ADDENDUM #1 – MAY 20, 2015

WEST VIRGINIA PARKWAYS AUTHORITY
PLANS, SPECIFICATIONS, AND CONTRACT DOCUMENTS
FOR

CONTRACT NO:
METAL ROOF AND SIDING REPLACEMENT 2015

Wall Area Diagram

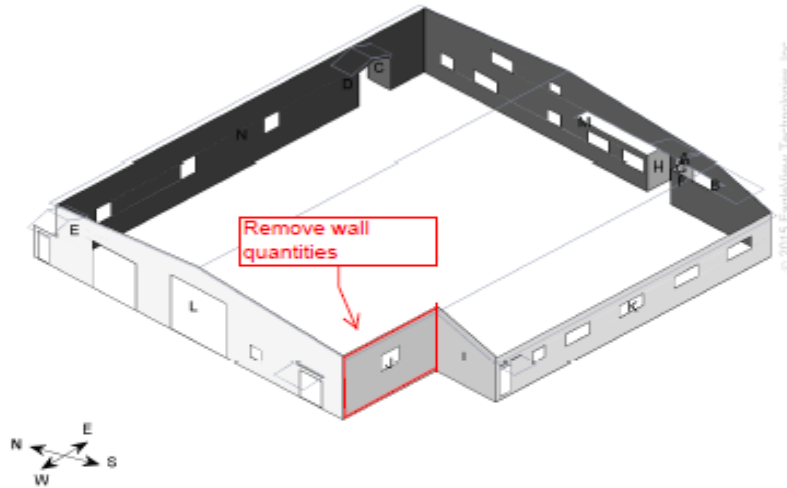
Remove the wall J, 396.8 square feet of quantity for siding and insulation from the Proposal and and replace illustration in appendix C WALL AREA DIAGRAM with the attached illustration.

Total Wall Area = 5532.6 sq ft, with 14 facets.

Total Wall Area with Windows and Doors = 6,248 sq ft
